TO: Mercedes-Benz Dealer Principals, General Managers, Sales Managers, Service Managers, Parts Managers	FROM: Thomas Brunner, Department Manager, Vehicle Compliance and Analysis, Engineering Services
RE: <b>Recall Campaign 2016050008 – Check and Replace Drive Shaft on Model 190 (AMG GT-Class) MY 2016</b>	DATE: July 22, 2016

Campaign No. 2016050008, July 2016

SUBJECT: **Model 190, Model Year 2016**  
**Check Drive Shaft, Replace if Necessary**

Figure 1

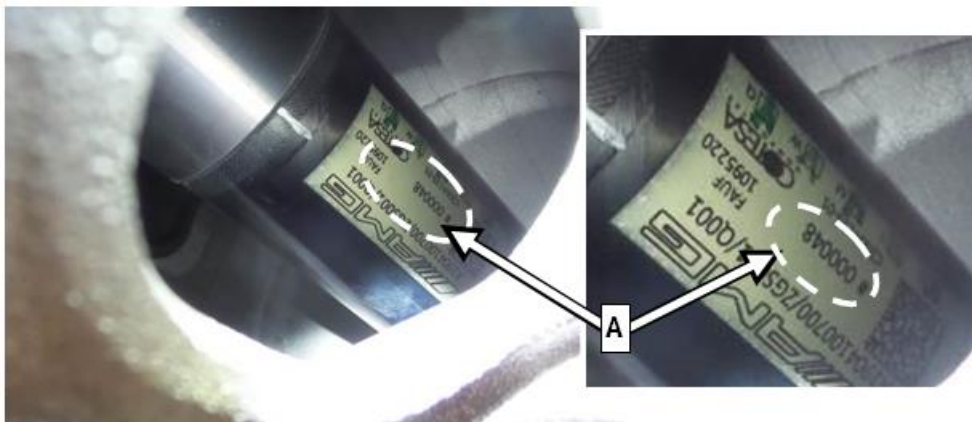
1. Open maintenance access on engine-side drive shaft housing.
2.  Check drive shaft production number (A, Figure 1).
  - If production number is **greater** than **000322 (OK)**: Procedure is complete.
  - If production number is **less** than or **equal** to **000322 (NOT OK)**: Proceed to step 3 (below).

If label is not visible start engine briefly then turn off engine and check again (repeat as necessary until label is visible).

Figure 2

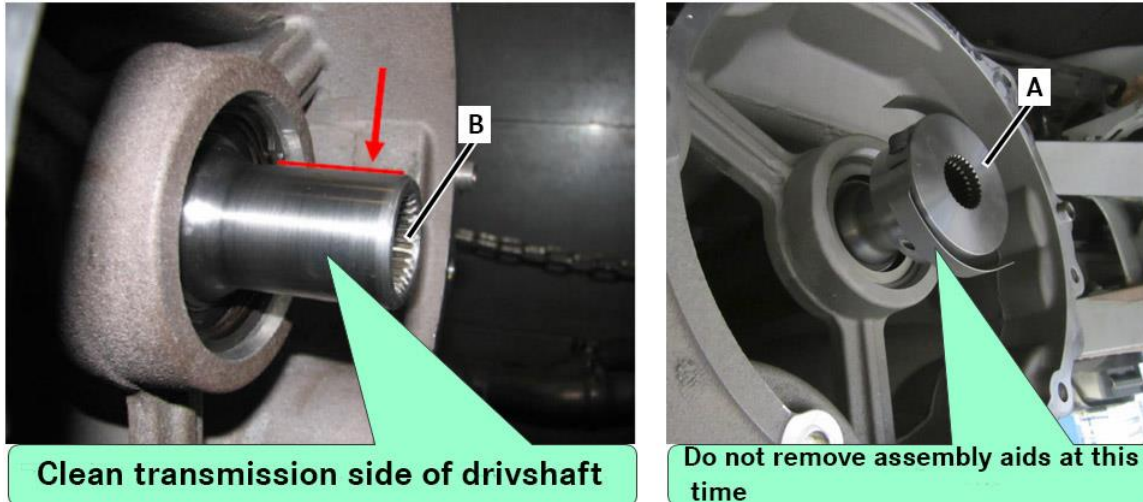
1. Clean transmission side of drive shaft end (arrow, Figure 2) of any lubricants.
2.  Slide new compensating ring (A, Figure 2) onto driveshaft (arrow) **up to end stop**.

Do not remove assembly aids/fastening plates (Figure 2) at this time.

Figure 3

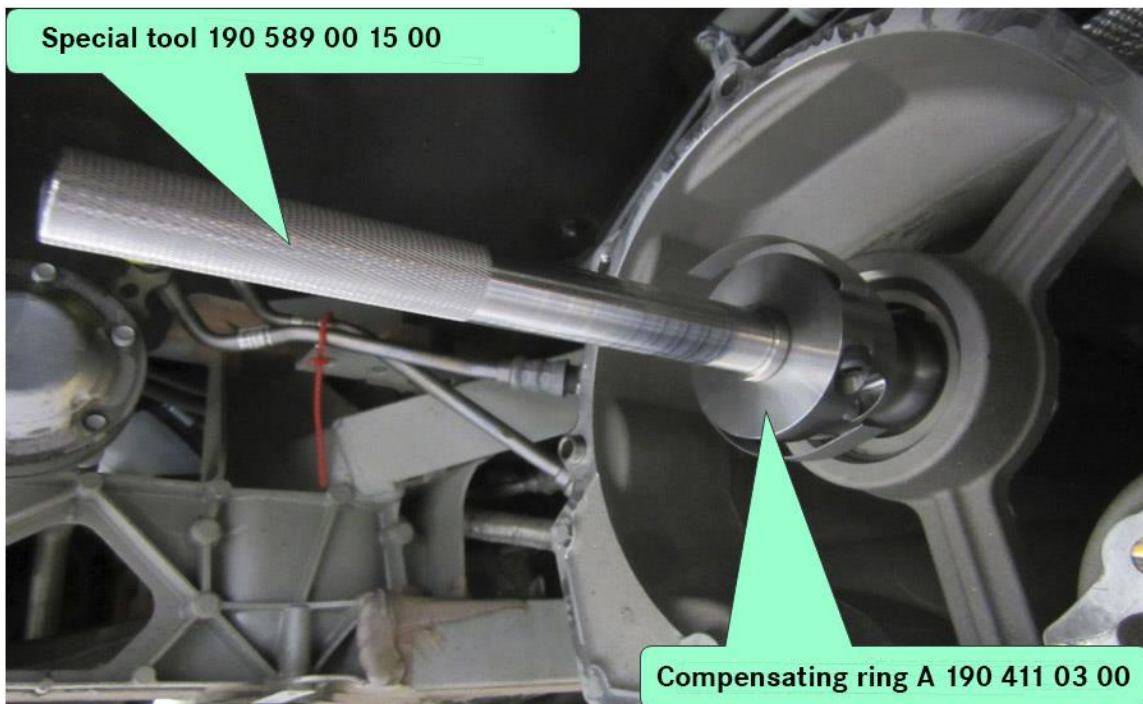
3. Center drive shaft gearing (B, Figure 2) and compensating ring (Figure 3) using assembly drift;  special tool: 190 589 00 15 00 (Figure 3).

Figure 4

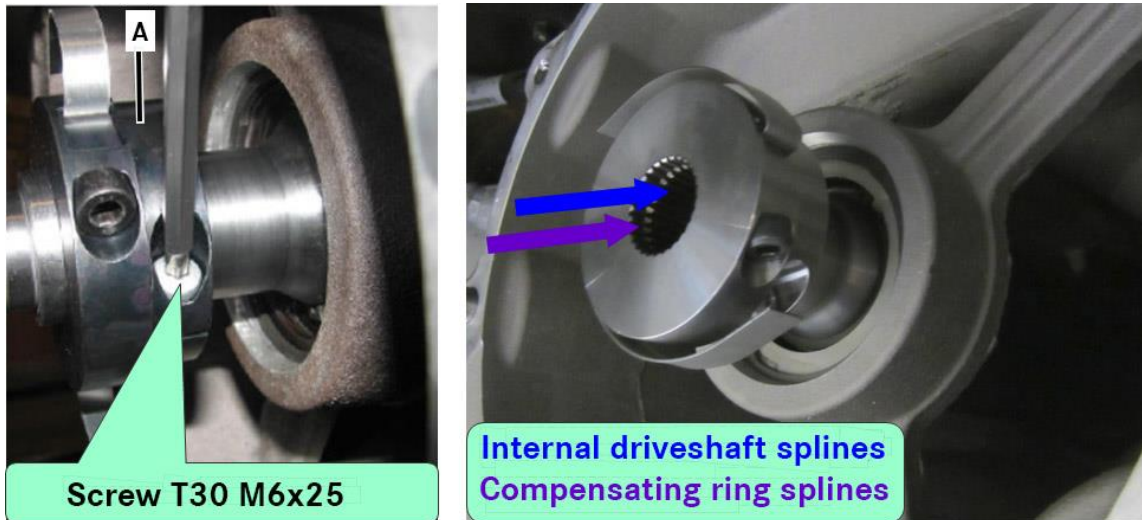
4. Tighten compensating ring's clamping ring (A, Figure 4) to drive shaft using **new** clamping screw (Figure 4); **Nm** torque **new** clamping screw (Figure 4) to 10 Nm. The assembly drift (special tool, Figure 3) may now be removed.

- Do **not** remove assembly aids/fastening plates (arrow, Figure 5) at this time.
- The drive shaft gearing is now synchronized with the compensating ring's gearing.
- The **new** clamping screw (Figure 4) is coated with thread locking compound.
- Part number for **new** clamping screw (Figure 4) is: N 000000 006551

Figure 5

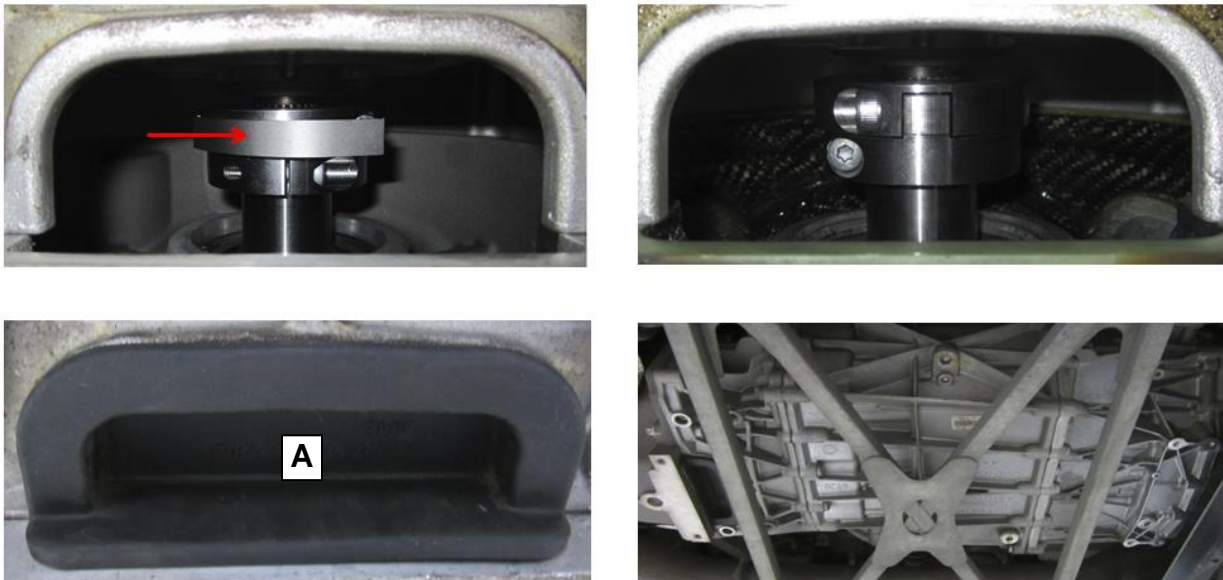
- Remove assembly aids (arrow, Figure 5).
- Reinstall rubber plug (A) into lower opening in drive shaft housing.
